SUBJECT: ALLEGATIONS BY EARL KENT CONCERNING ADEQUACY
OF WELDMENTS AT SAN ONOFRE UNITS 1, 2, AND 3

Plant Name: San Onofre Nuclear Generating Station Units 1, 2 and 3
Licensing Stage: Unit 1 operating, Unit 2 and 3, OL
Docket Numbers: 50-206, 361, 362
Reviewer: D. E. Smith
Responsible Branch & Project Manager: LB #3; H. Rood
Description of Task: Safety Evaluation Report of statements by
Mr. E. Earl Kent on the adequacy of the
weldments at these plants

ATTACHMENT
SOUTHERN CALIFORNIA EDISON
SAN ONOFRE NUCLEAR GENERATING STATION
UNITS 1, 2 AND 3
DOCKET NOS. 50-206, 361, 362
SAFETY EVALUATION REPORT
MATERIALS ENGINEERING BRANCH
MATERIALS APPLICATIONS SECTION

Fig. C8.8.6—Examples of end returns (boxing)

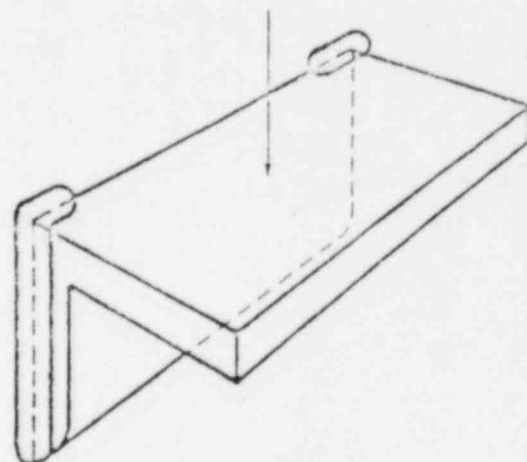
"8.8.6 In earlier testing of flexible beam-to-column connections in which the welds were subjected to combined shear and bending, it was found that end returns (hooking the weld) around the top of seat angle connections (see Detail B of Fig. C8.8.6) did not necessarily increase the strength of the connection. In the case of header angles, as shown in Detail A, end returns (boxing) tend to delay the initial tearing of welds under ultimate failure conditions.

This commentary makes note that the ultimate, static load (which is applicable to cable tray hangers and pipe supports at these plants) are not increased by end returns.

In conclusion, the Bechtel Power Corporation showed knowledge of the end return requirements, and used them when there was a design need. Accordingly, this allegation is viewed as not having any merit.
